SUBJECT: NuScale Power, LLC Supplemental Response to NRC Request for Additional Information No. 110 (eRAI No. 8932) on the NuScale Design Certification Application

NuScale Supplemental Response to NRC Request for Additional Information eRAI No. 8932

NRC Question No.: 03.07.02-2

NRC Question No.: 03.07.02-3

Figure 3.7.2-67: Isometric View of SASSI2010 Triple Building

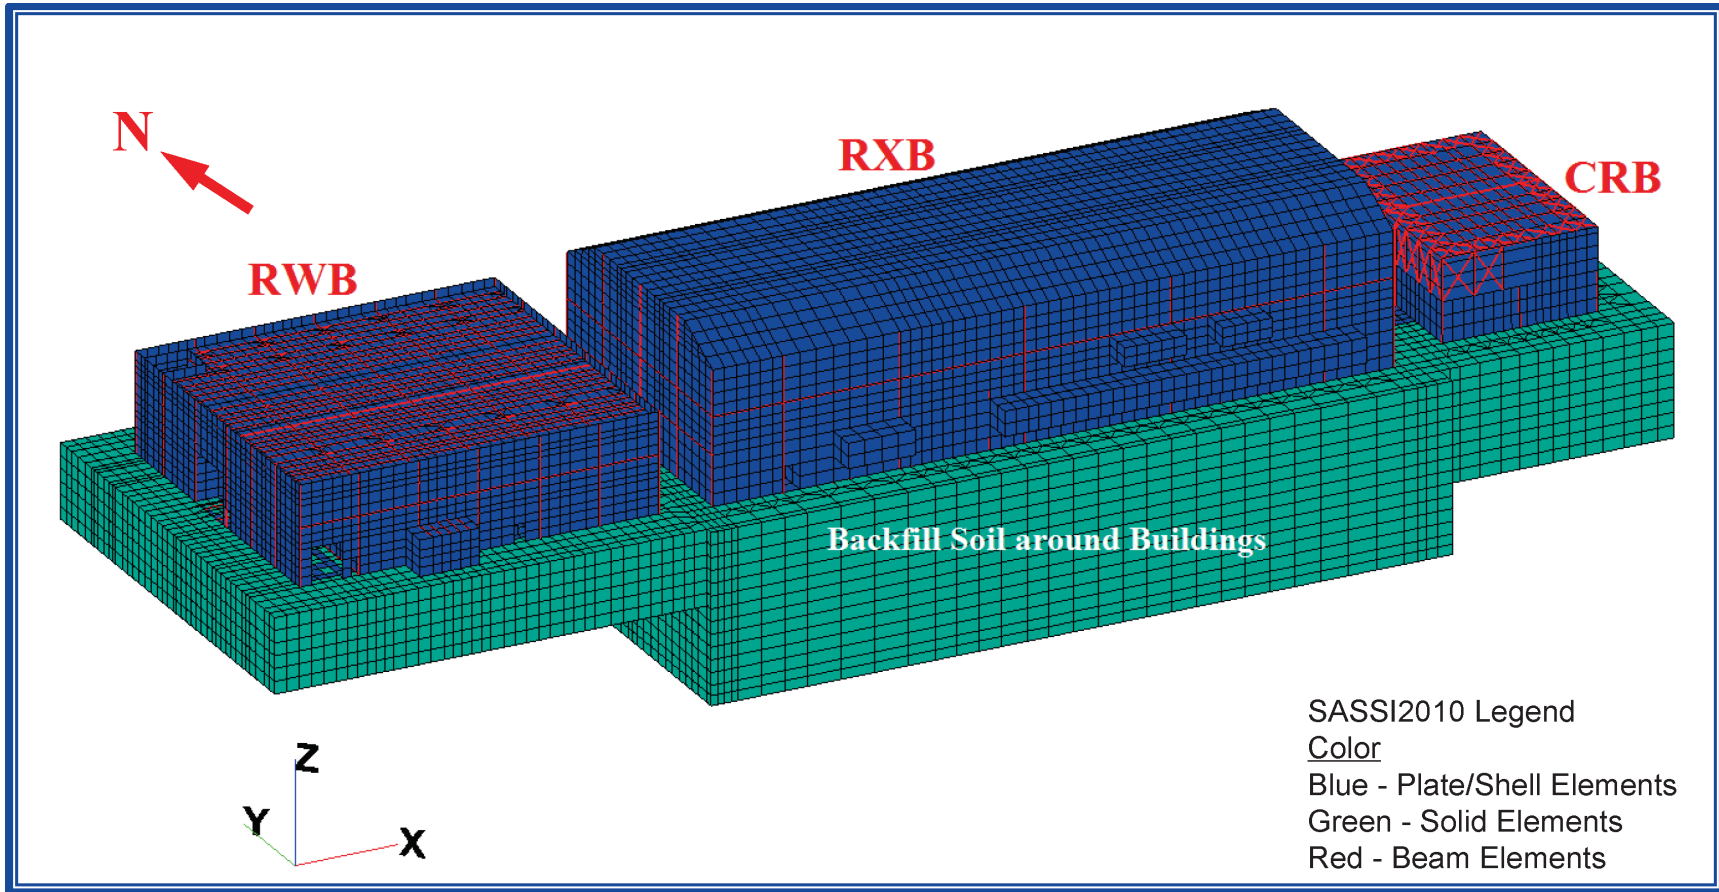
- d. In Figure 3.7.2-20 in the FSAR, The applicant is requested to clarify if the bottom two layers represent the basemat which is to be considered as part of the RXB and color-coded accordingly (in blue). The figure also appears to show mixed coloring for certain elements in the bottom two layers. Please explain what the mixed colors represent for these elements.

A legend has been added to Figure 3.7.2-67. Similarly, a legend has been added to other SASSI2010 model figures, for clarity.

FSAR Tier 2 Tables 3.7.2-19 and 3.7.2-21 and FSAR Tier 2, Figure 3.7.2-67 have been revised as described in the response above and as shown in the markup provided in this response.
